# NOTICE OF DECISION

## PLANNING ADMINISTRATOR DECISION FOR SITE PLAN REVIEW

**CASE TYPE:** Class 2 Site Plan Review  
**AMANDA NO.:** 21-109485-RP  
**DATE OF DECISION :** September 1, 2021  
**PROPERTY LOCATION:** 3980 Airway Drive SE  
**APPLICANT:** Paul Young  
**ZONE:** IP (Industrial Park)  
PS (Public Service)  
**COMPREHENSIVE PLAN:** Industrial  
Parks, Open Space and Outdoor Recreation  
**OVERLAY:** McNary Field and Airport Overlay

Site:	Salem Airport	Drawing:	Hangar Site Map	Project:	0000416	Drawn:	Paul Young	Notes:	Word of Life Fellowship Church
Title:	Aircraft Hangar	Scale:	1/4"=1'-0"	Date:	05/11/2021	Rev:	A		P.O. Box 17817 4705 Portland Rd NE Salem, OR 97305

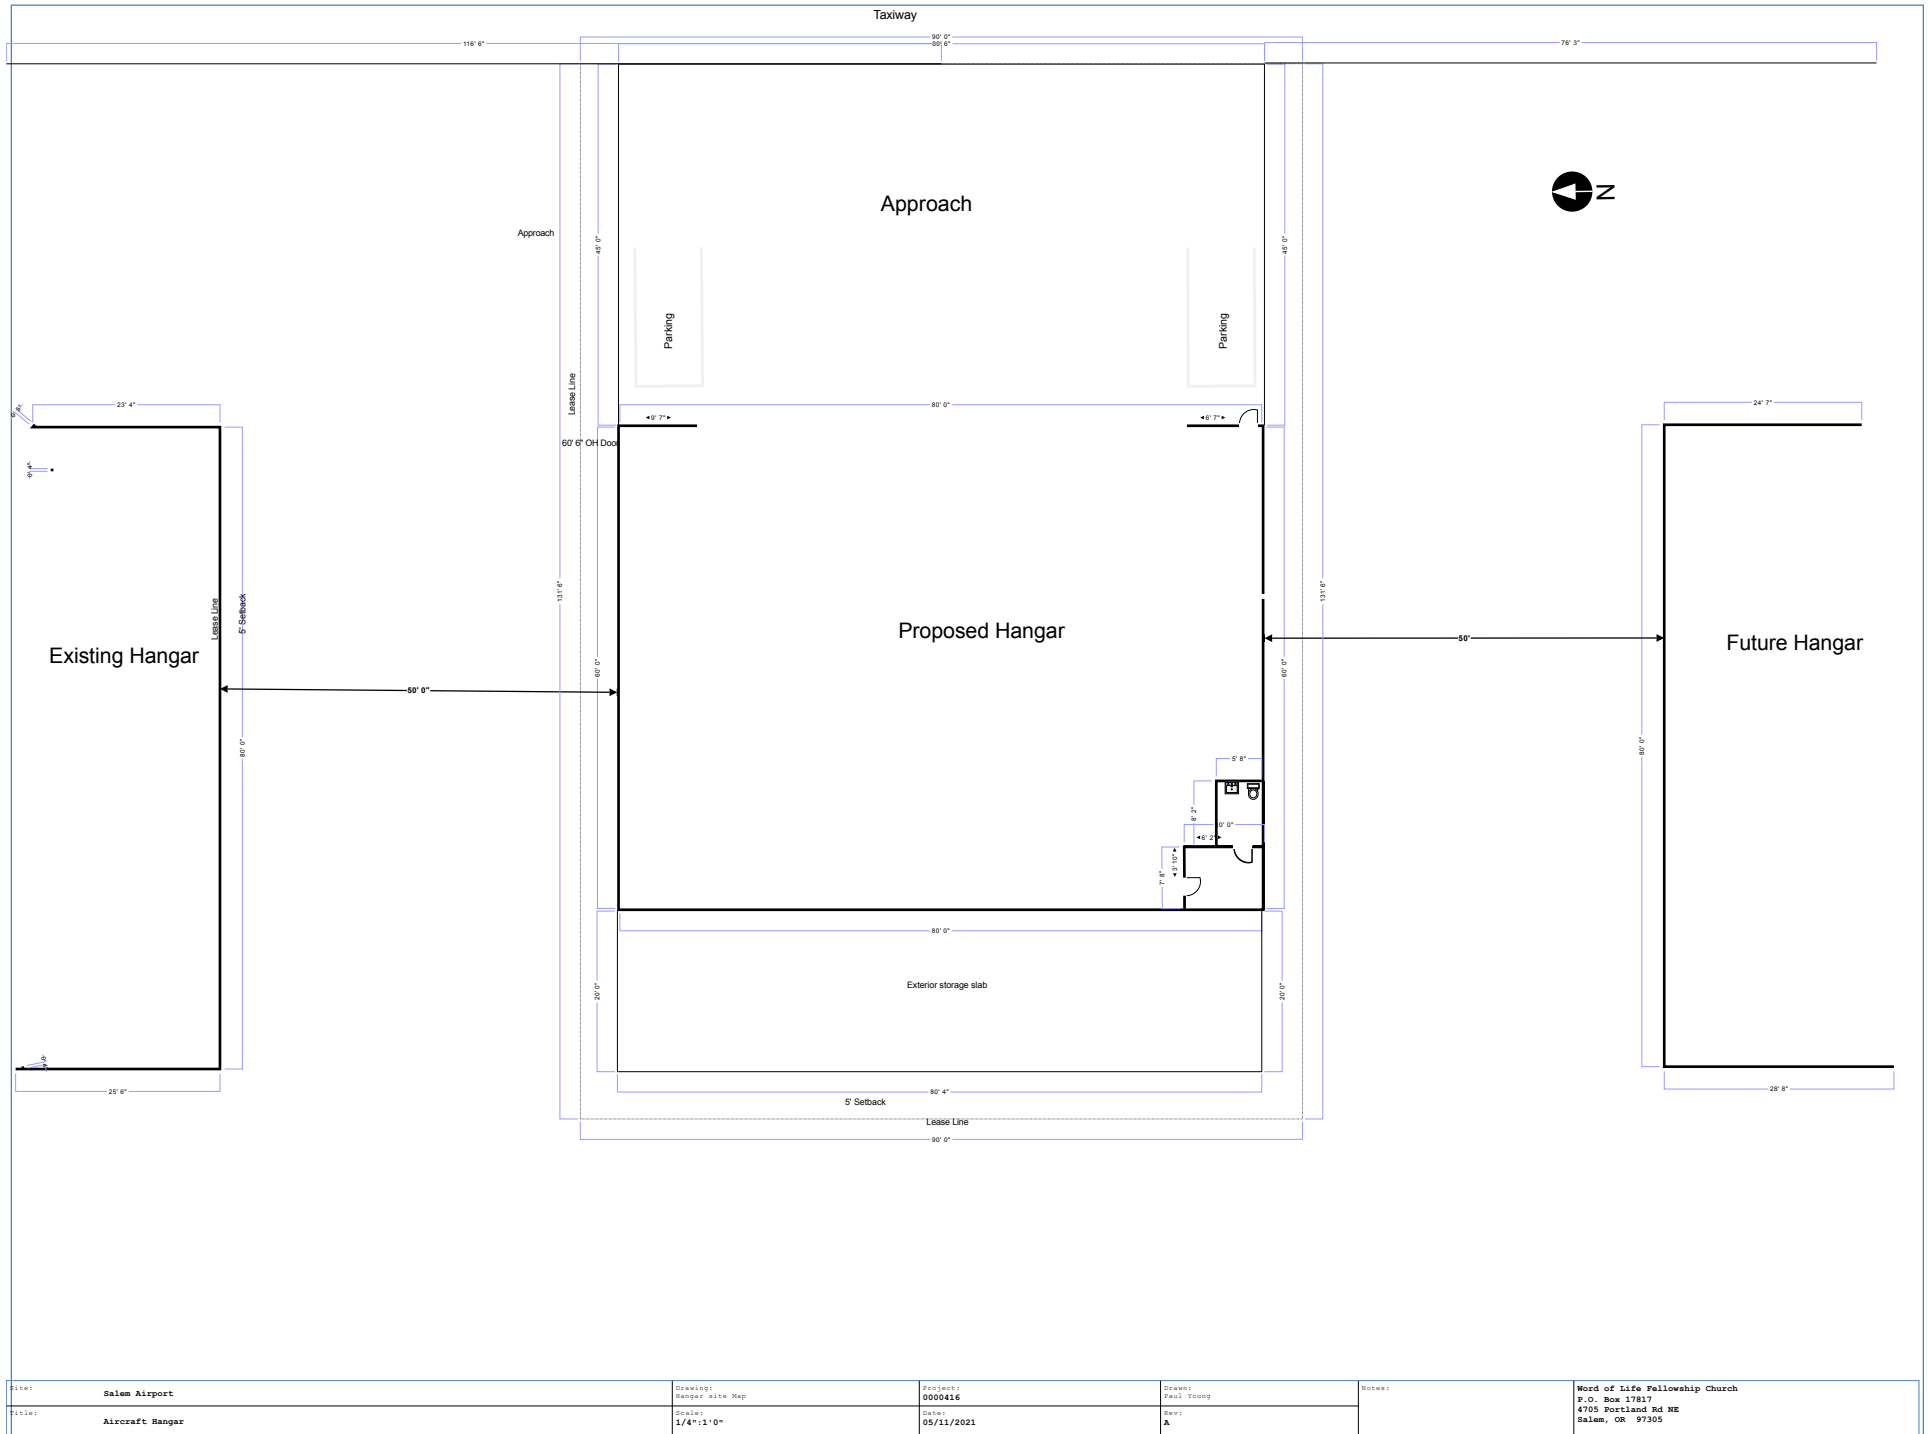
**Staff Response:** The proposed hangar is approximately 30 feet in height requiring a minimum 20-foot setback. The proposed hangar location exceeds the minimum 20-foot setback requirement for buildings and accessory structures. Therefore, the proposal complies with the setback requirements.

**Staff Response:** The proposed hangar is being constructed within the IP zoned portion of the site. The proposed hangar is approximately 30 feet in height and would be in compliance with the height limit of 45 feet in the IP zone.

**Staff Response:** The proposed site plan indicates adequate setback bufferyards and site landscaping area to meet SRC 554.010(d). No interior parking lot landscaping is required by SRC Chapter 806.

**Staff Response:** The applicant states that no employees will be working at the hangar. The minimum number of parking spaces is 1 space per 5,000 sq. ft. The proposed hangar is approximately 4,800 square feet requiring one off-street parking space. The applicant's site plan indicates two off-street parking space are provided. Carpool/vanpool or compact parking is not required.

**Staff Response:** The proposed site plan indicates the parking and vehicle use area setbacks exceed the minimum 6 to 10 foot setback requirement to property lines abutting streets. Therefore, the proposal complies with the setback requirements.

**Staff Response:** The applicant's site plan indicates a 5-foot-wide paved pedestrian walkway in between the exterior wall of the new hangar and the off-street parking area is proposed. The proposal meets this standard.

**Staff Response:** As proposed, the parking spaces meet the minimum dimensional requirements of SRC 806.

**Staff Response:** The proposed hangar is approximately 4,800 square feet in gross floor area, requiring a minimum of four bicycle parking spaces. The site plan indicates four bicycle parking spaces are being provided by two U-shaped bicycle racks. This standard is met.

The Building and Safety Division reviewed the proposal and commented "With the property separation distances shown, all construction types except Type V construction may be used. The proposed hangar height is called out at 30-feet. If the door height is taller than 28-feet all fire suppression requirements will need to be for a Group I hangar.

If the hangar is under 28-feet, the hangar can be classified as a Group III. Development of the hangar will be reviewed for conformance with these requirements at the time of building permit application review.”

The Fire Department has reviewed the proposal and commented, “Unable to evaluate the existing water supply from the provided site plan. Fire Department access and water supply will be required per the Oregon fire code and will be reviewed for conformance at building permit application.
